PN18032564803

Applicable to: Hydrant couplers that utilize fuel reference pressure in lieu of air reference pressure, including 64803 and 64903

Field Modification of the Vent Port

Product News Bulletin

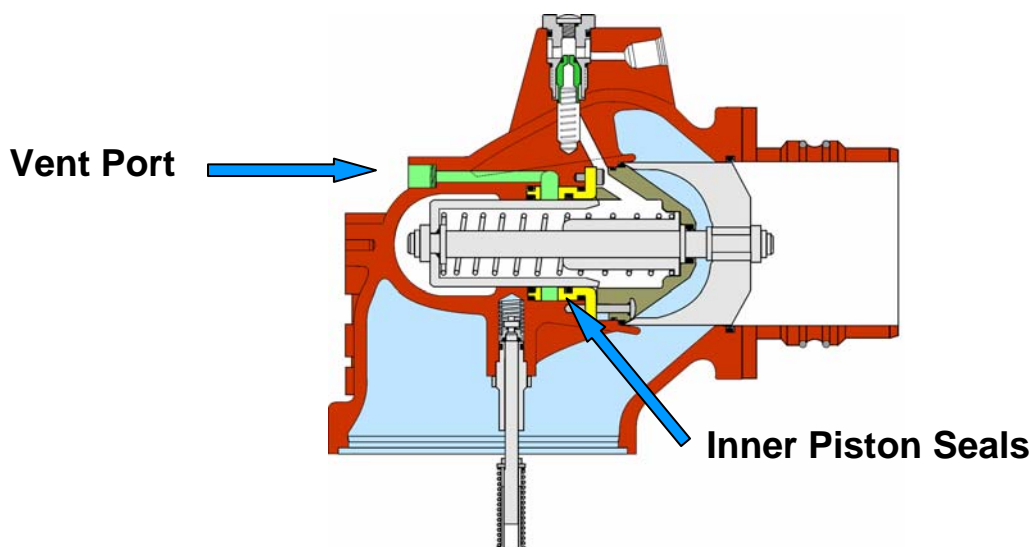
All Eaton Carter® brand hydrant couplers, except for the 60600 series of couplers, include a vent port (please review the image below). This vent port is intended to allow any fuel that leaks by the inner piston seal to be exhausted. This is done to prevent cross-contamination of the air reference pressure with fuel in air operated couplers, including the 64800, 64801, 64900 and 60700-1. This vent is also present in fuel reference pressure operated couplers, including the 64803, 64903 and 64702. The purpose of this vent on these couplers is to act as a tell-tale if the inner piston seals were to become damaged or excessively worn and begin to leak. We would also note that, even with the seals in good condition, there may be some small amount of leakage. This small amount of leakage will manifest itself as a stain around the vent port or minor weeping. The seals around the inner piston will not remove all of the fuel from the surface of the piston. When the unit is in operation the inner piston will oscillate, opening and closing to maintain the downstream pressure. As this occurs small

amounts of fuel will be wiped off the piston and remain in the void area between the inner piston seals. Given enough time, this fuel will accumulate and the slight weeping or staining of the area around the vent port can occur. This phenomenon is more common on fuel reference operated couplers as the amount of fuel that can be deposited in the void area between the inner piston seals is effectively doubled. However, as cross-contamination in a fuel-over-fuel system is not a concern, tapping and plugging the vent port may prevent a coupler from being unnecessarily removed from service due to a perceived leak. We have recently completed testing and determined that this vent may be plugged on fuel reference operated couplers, including the 64803 and 64903. **The vent port on the 64702 can not be plugged due to the shape of the vent port. This field modification should not be accomplished on air reference operated couplers as this would circumvent the primary purpose of the vent to prevent cross contamination of the air reference pressure system.**

The first step will be to inspect the raised area around the vent port opening. You may find that the original vent port is not centered in this raised area. Measure the area with the thinnest wall thickness. If the thinnest portion is less than .100", that housing can not be modified. For those couplers with a wall thickness greater than .100", remove the pressure control elbow from the coupler lower half and remove all internal components of the control elbow, leaving the vent port filter and retainer in place. The current hole is the appropriate size to accept a 1/4" NPT tap. Obtain a good quality 1/4"-18 NPT tap. You will note that the depth of the hole up to the filter disc will be deep enough for 1/4" NPT threads. Some brands of tap will have a tapered point on the leading end. Depending on the brand of tap that you have it may be necessary to grind this tapered point flat.

Measure the depth of the hole and mark the tap, measuring from the leading end. Insert the tap in the hole and, while pressing inward, begin to screw the tap in. Use liberal amounts of thread cutting oil intended for use with aluminum - Soluble, Light Base, or Lard Oil, or Mineral Oil w/Lard, or Light Oil. Remove the tap frequently and remove metal shavings to prevent build up of metal shavings from damaging the threads. Continue to screw in the tap up to the measured mark. Remove the filter screen and retainer. Remark the tap for this new depth and tap to that depth. Clean the threads and insert a 1/4" pipe plug to check the threads. Use an appropriate material pipe plug (stainless steel is preferred). The preferred type of pipe plug will have a low profile and will include a recessed hex socket similar to image above. Whatever type of plug is used, make sure that it has tapered threads. Some pipe plugs include straight pipe threads similar to a screw. The plug should screw into the threaded hole approximately 1/4 to 1/3 its threaded length with little effort. Some brands of NPT taps work better on blind holes than others. Bottom taps for NPT threads are not available. Some taps will have

a longer cutting edge past the first cutting thread than others. It may be necessary to grind more material off the leading end to obtain the appropriate thread depth. Use caution not to over tighten the tap. If the tap bottoms out in the hole and you continue to turn it, you can remove all of the threads from the hole.

Clean the housing and vent port threads and pipe plug to remove all metal shavings and cutting oil. Apply a good quality anaerobic type thread sealant such as Hercules Block. Insert the pipe plug and tighten. There are no torque recommendations for tapered threads. Do not over tighten. This is a tapered pipe plug in a tapered hole. Over tightening can crack the housing. The best approach is to tighten to a good snug fit and check for leaks. If the joint does leak it will be necessary to remove the plug and clean off all thread sealant. An anaerobic thread sealant will set up quickly when in contact with certain active metals such as aluminum. Apply new sealant to pipe plug and reinstall a little tighter.

Not all fuel reference operated couplers will require this field modification. We have recently modified new production units to include 1/4" NPT threads in the vent port. All 64803 hydrant couplers with serial number 390 and higher and all 64903 hydrant couplers with serial number 101 and higher will include this upgrade. For those hydrant couplers, remove the filter and retainer and install a pipe plug as described above.
